DW/BG  
15391  
15 November 2016

**SUBMISSION - SYDNEY OLYMPIC PARK MASTER PLAN 2016 REVIEW  
SITE 4B, SYDNEY OLYMPIC PARK**

**SUBMISSION TO SYDNEY OLYMPIC PARK MASTER PLAN 2030  
SITE 4B, SYDNEY OLYMPIC PARK**

**Figure 2 – Central Precinct Site FSR Plan**  
*Source: 2016 Review*

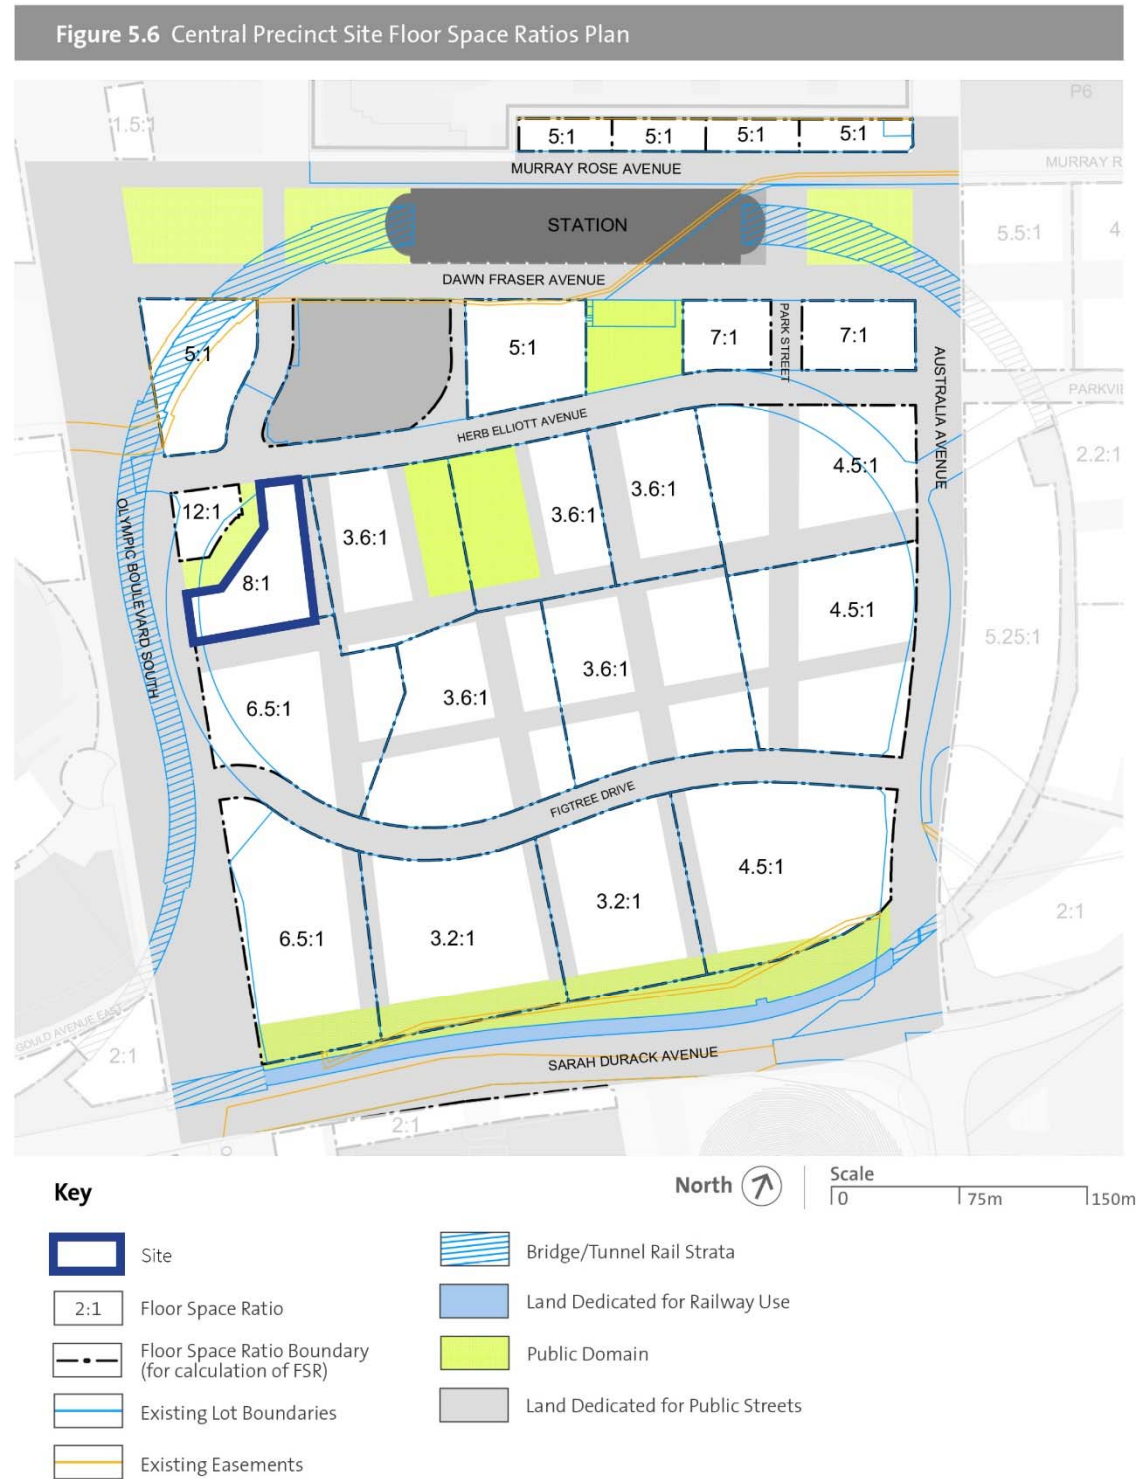
Figure 5.6 of the 2016 Review identifies Site 4B with a FSR of 8:1, up from 6.5:1 in Master Plan 2030 (**Figure 2**). This would represent a target GFA of 33,304m<sup>2</sup> on the site, that correlates to 23,530m<sup>2</sup> of FSR remaining on the Site after subtracting the existing Stage 1 GFA.

- Amendment to Figure 5.6 – Central Precinct Site Floor Space Ratios Plan to allow a FSR of 9:1 on Site 4B.
- Amendment to Figure 5.7 – Central Precinct Land Uses Plan to allow Mixed Commercial and Residential on a wider portion of the site as shown in **Figure 7** equating to dimensions approximately 50m (L) and 24m (W).
- Amendment to 4.6.8 Podium Design and Setbacks, providing a variation exception for Site 4B to the mandatory 28m podium height along Olympic Boulevard in order to achieve a podium transition from north to south along Olympic Boulevard.

**Figure 3 – Central Precinct Building Heights Plan**  
Source: 2016 Review

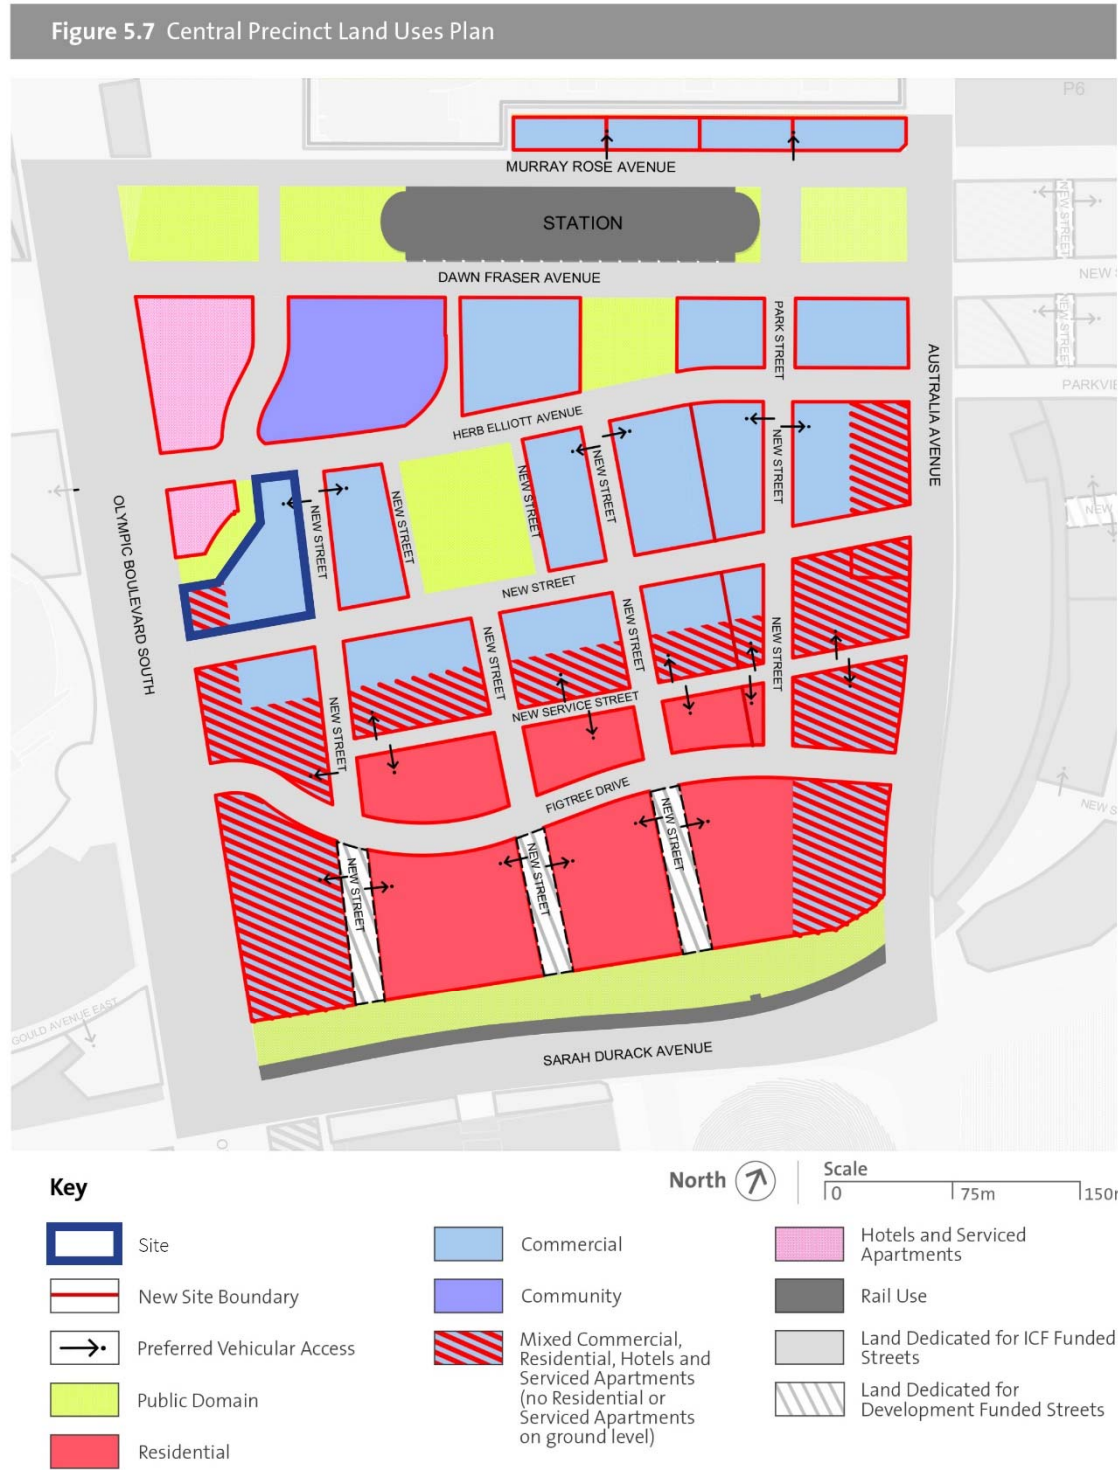
Figure 5.8 of the 2016 Review identifies Site 4B as a “Tower Zone – 45 Storeys (8 Storey block edge, towers above)” (**Figure 3**). This has changed from Master Plan 2030 that indicates building heights of 20-32 storeys at the fronting Olympic Boulevard and 8 storeys on the eastern part of the site.

## 45-STOREY HEIGHT LIMIT & 20M PODIUM

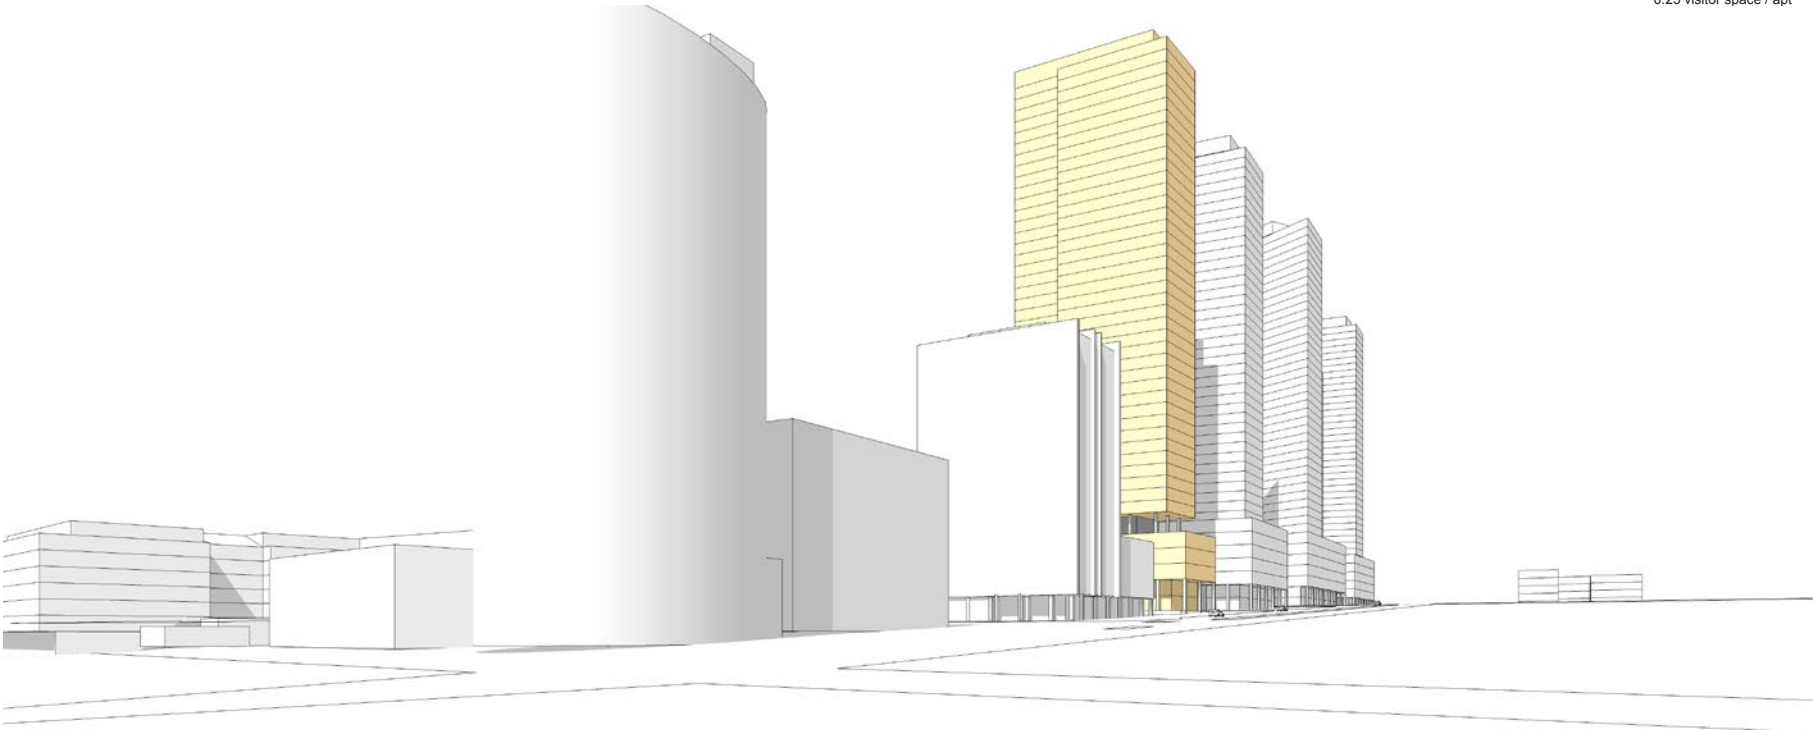
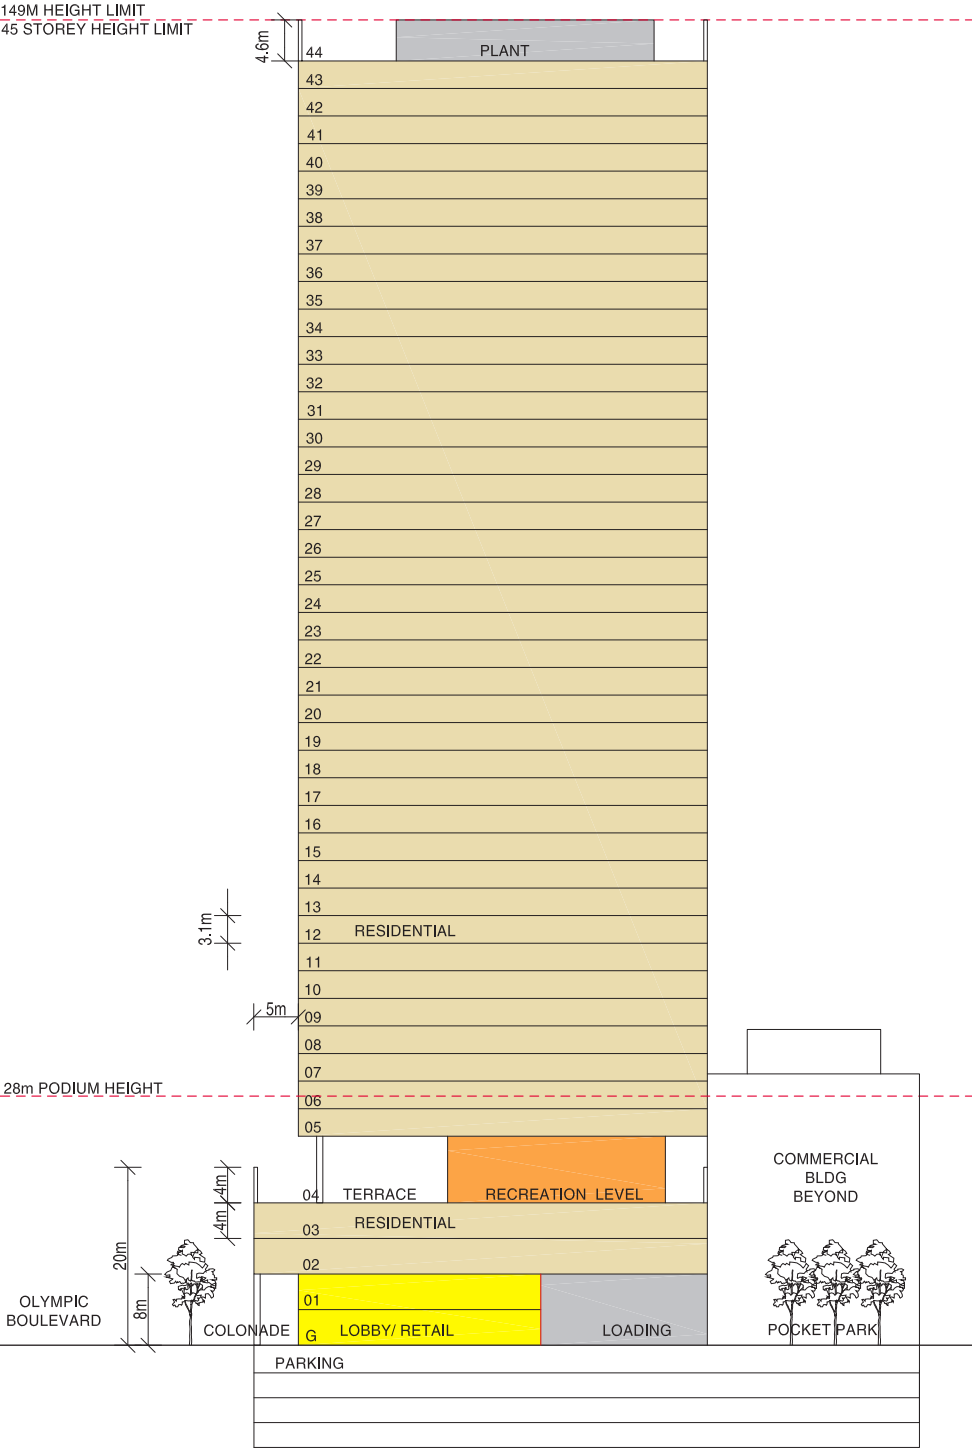
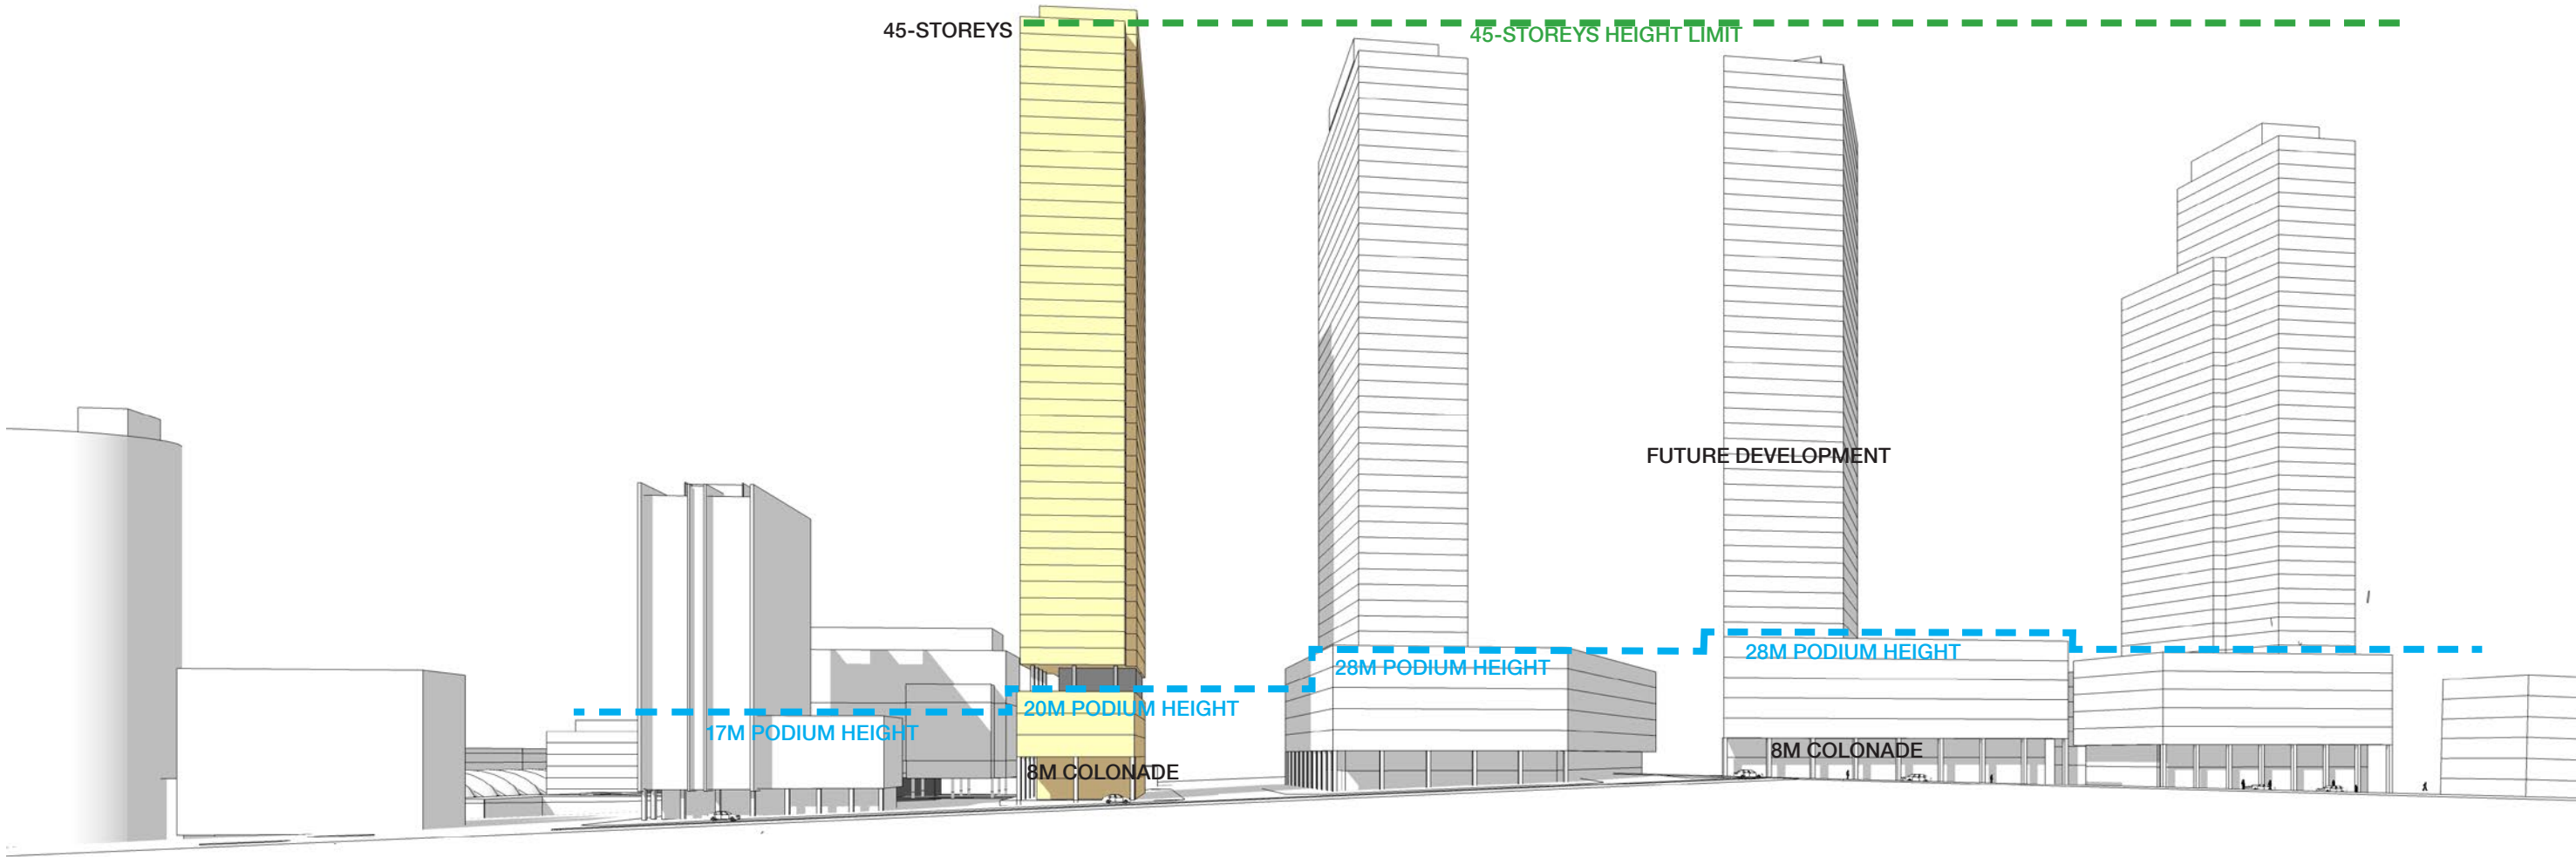
As can be seen with the building height study, a mixed use building with a slender residential tower that achieves an effective height of 45 storeys (ie 149m) generates a GFA of 30,067m<sup>2</sup>. Accordingly, the GFA for Site 4B (with existing commercial building) equates to 39,841m<sup>2</sup> or a FSR of 9.6:1.

Should a FSR of 8:1 be applied to Site 4B as proposed by the 2016 Review (and the podium height of 28m enforced), the GFA for the site would equate to 33,304m<sup>2</sup>. This results in a residual GFA on the site of 23,530m<sup>2</sup> when subtracting the GFA of the Stage 1 building.

Assuming design excellence is achieved a 10% bonus floor space is available for the site bringing the GFA of the site up to 36,634m<sup>2</sup> (or 26,860m<sup>2</sup> when subtracting the Stage 1 building) and FSR up to 8.8:1. Therefore when using the parameters above, a mixed use building with slender tower on Site 4B could only achieve a height of 37 storeys, comprising 7 storeys of podium (5,460m<sup>2</sup> of GFA) and 30 storeys of tower (21,400m<sup>2</sup> of GFA). Clearly a 37 storey development on Site 4B is inconsistent with the desired future character of Olympic Boulevard of the Central Precinct as expressed in the 2016 Review.
